Wyona Park Site Visit Plumbing Questions 8-19-2026

Wyona Park Restroom Building Details

Wyona Park Restrooms

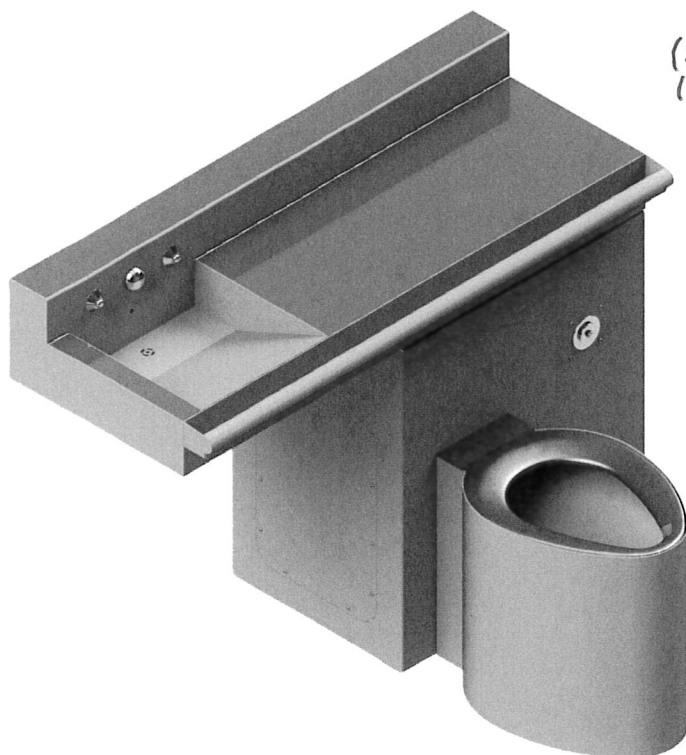
Also included is a map of building dimensions
